RENOVATION OF THE "OLD CITY WELL"

April 1990
"Specs"

Purpose: To repair and restore the original structure (cover building) to allow public entrance and viewing.

SHEET 1

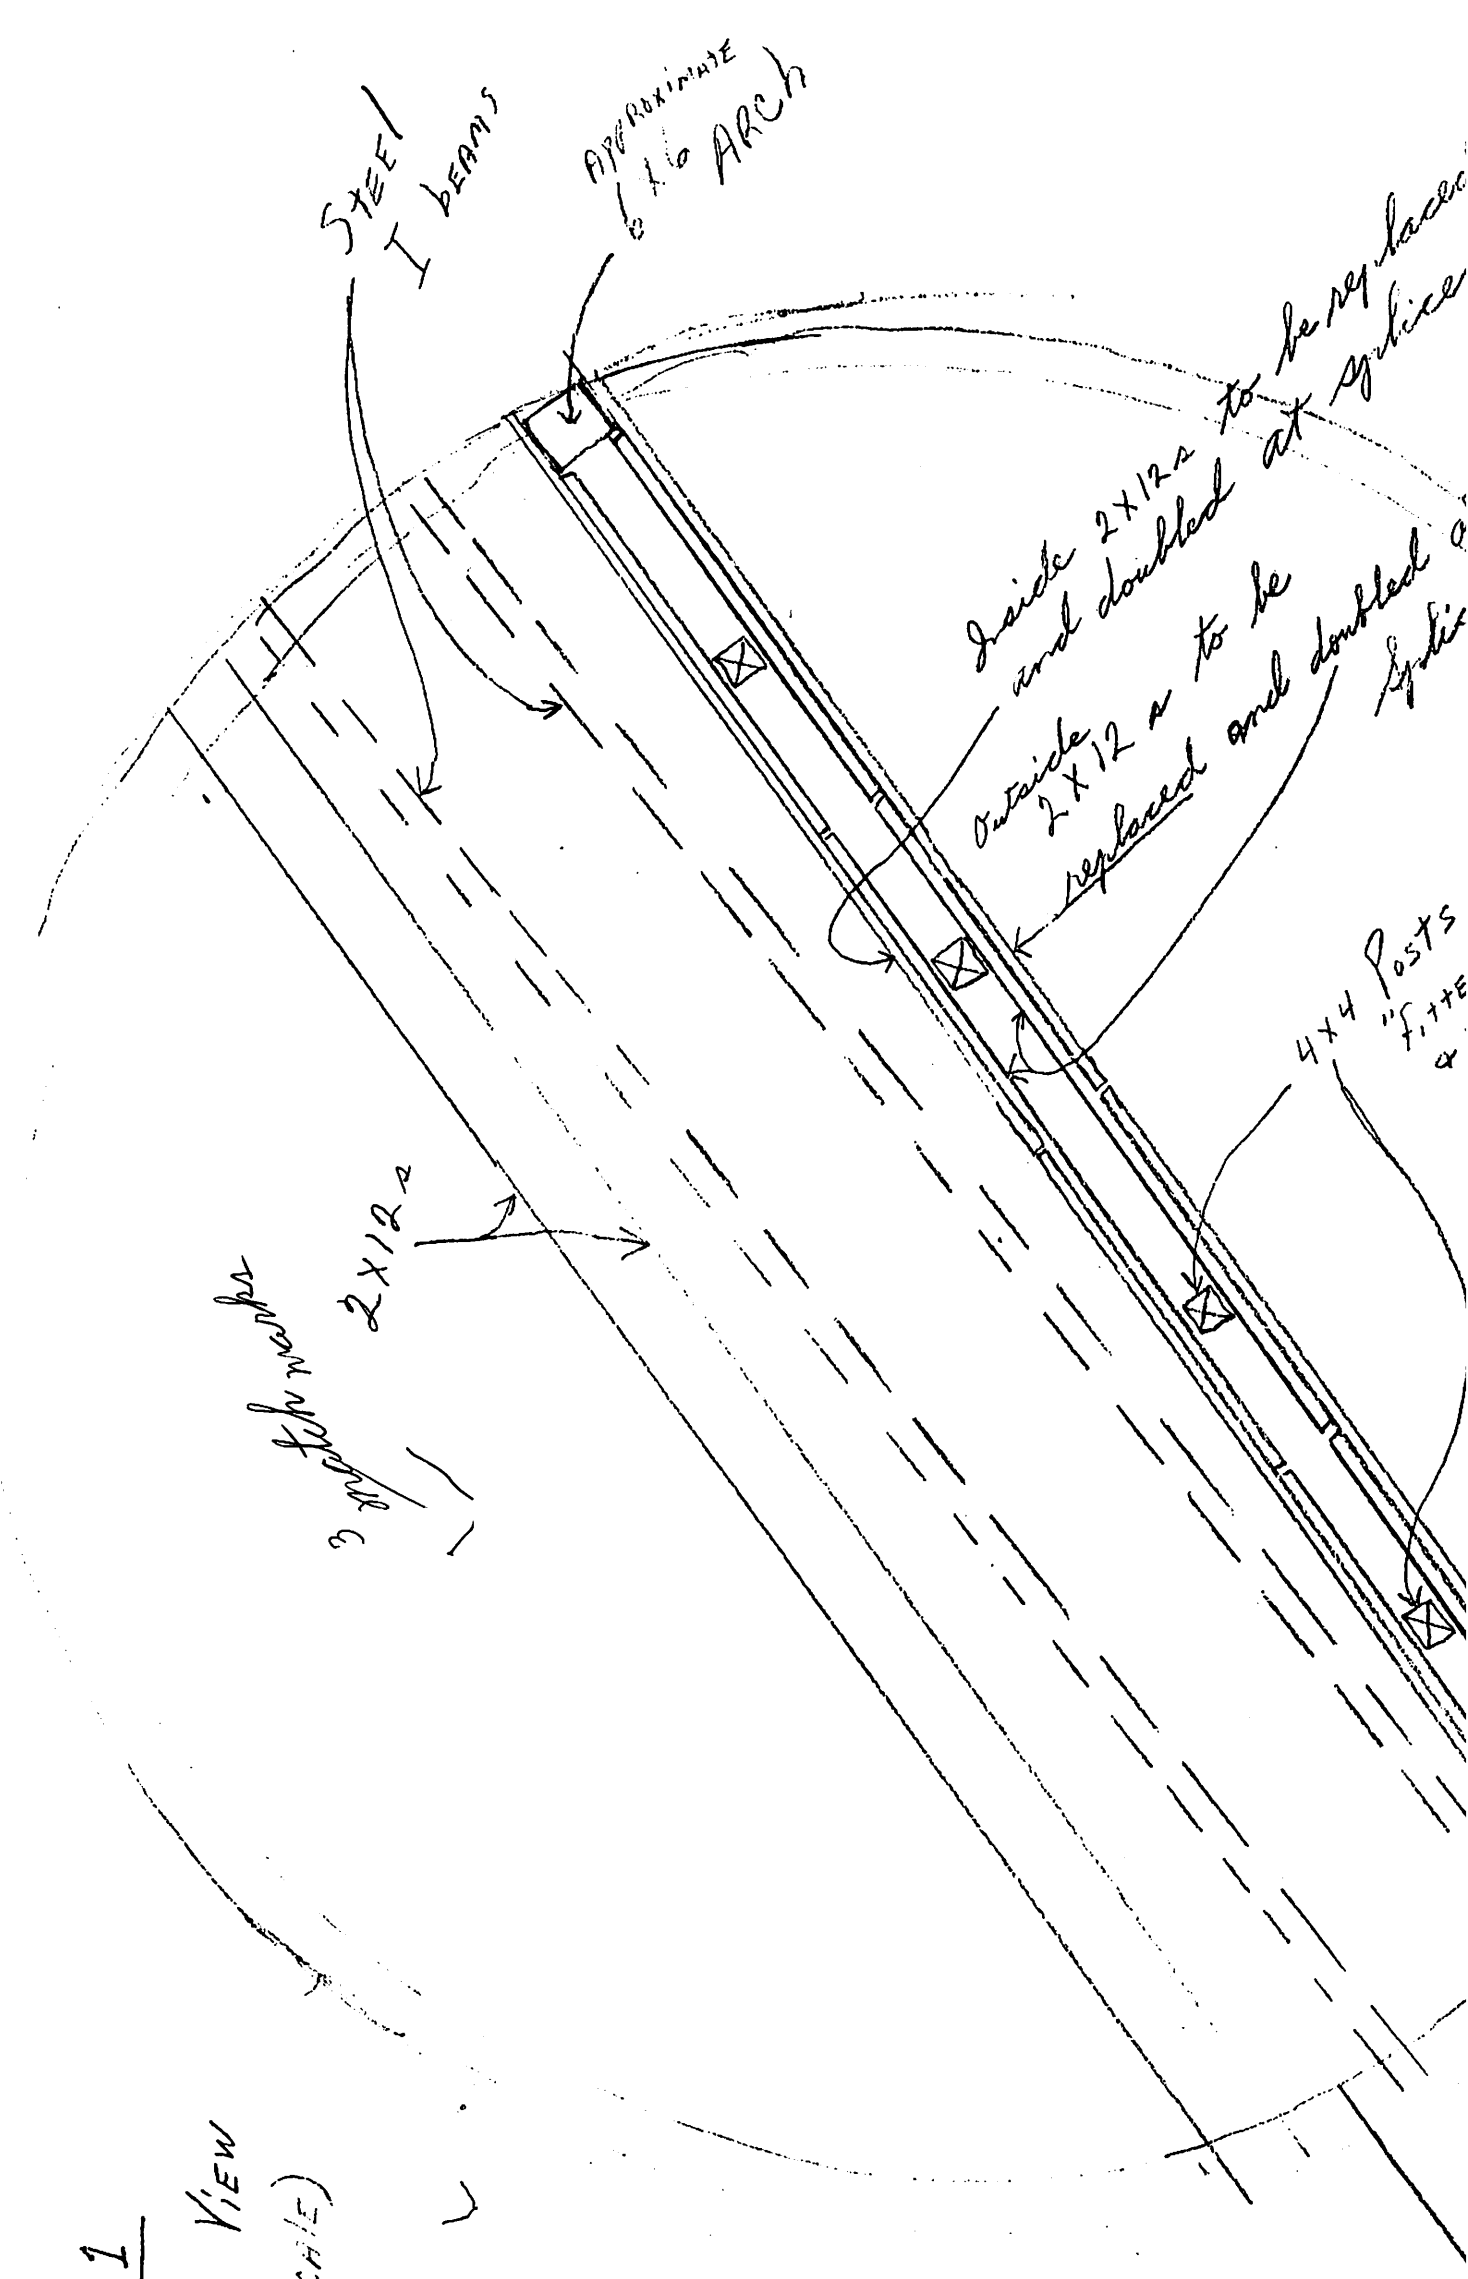
Inside 2x12s to be replaced
and doubled at splices. (See notes
on SHEET 2)

Outside 2x12s to be
replaced and doubled at splices
6 ft.

Splices to be lapped at least

4x4 Posts (8 ft on
centers)
"Fitted"
& bolted
See notes on
sheet 2

SHEET 2

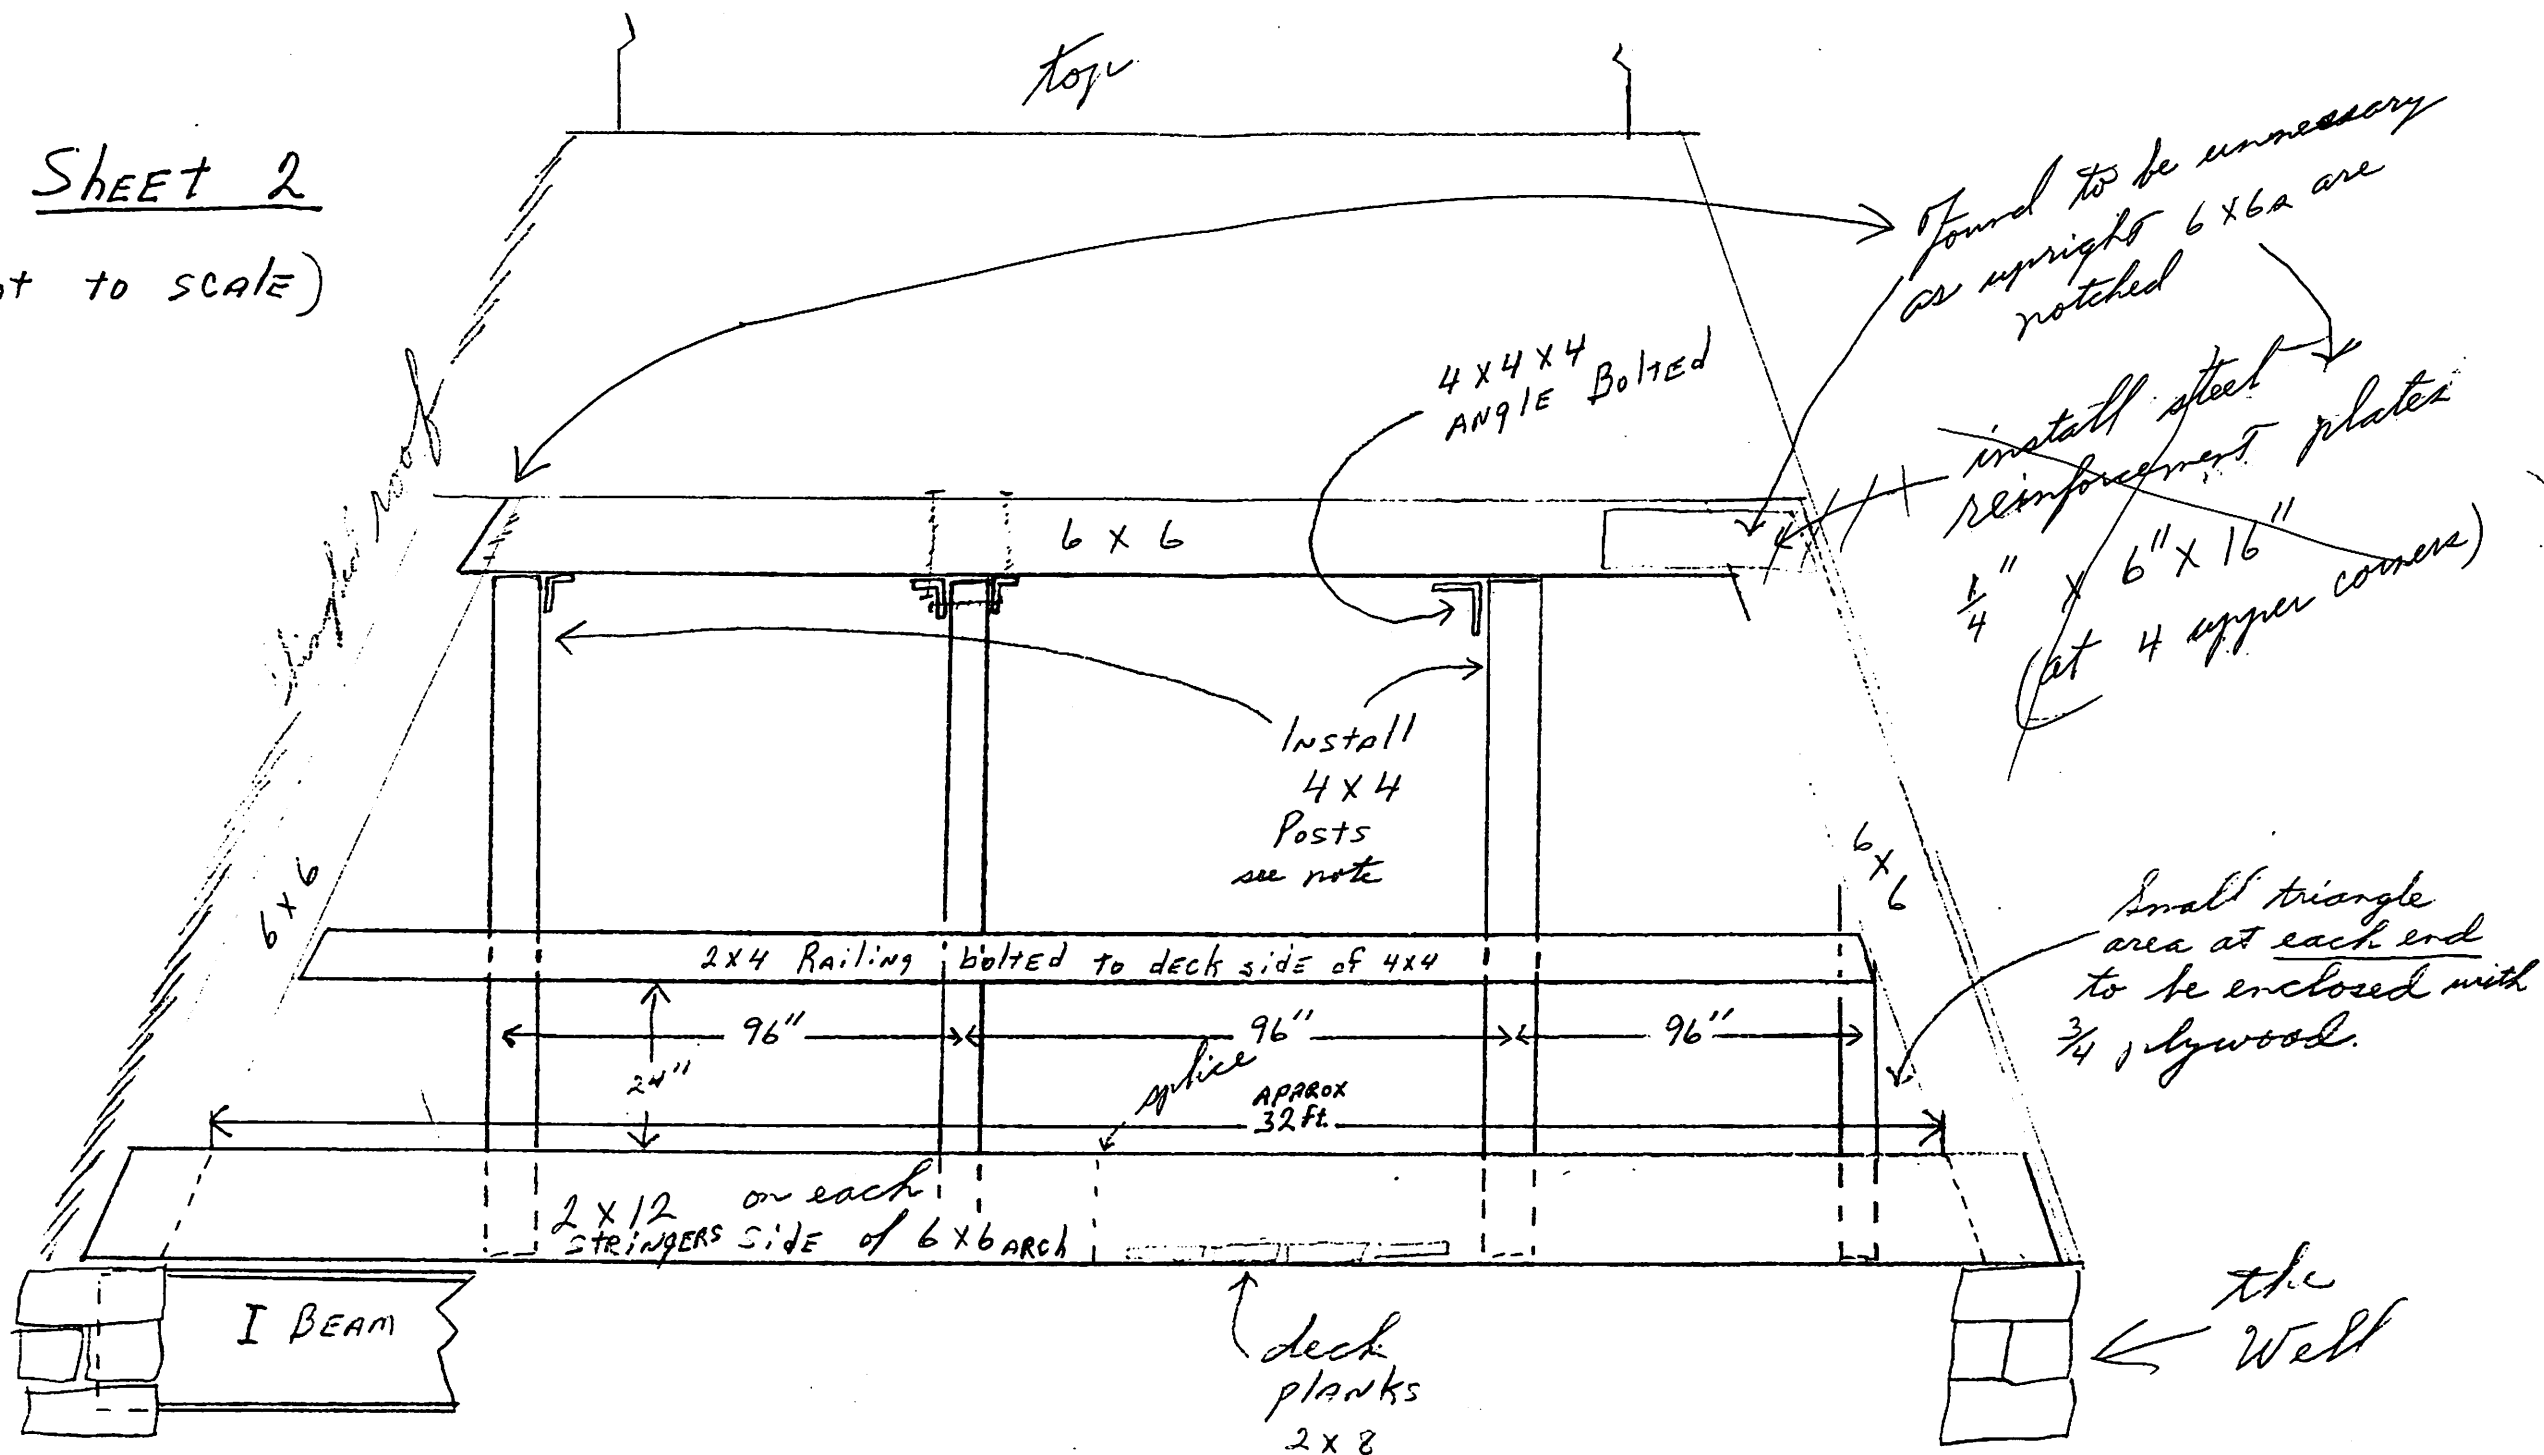
Found to be unnecessary
as uprights 6x6 are
notched

install steel
reinforcement plates
1/4" x 6" x 16"
(at 4 upper corners)

Small triangle
area at each end
to be enclosed with
3/4 plywood.
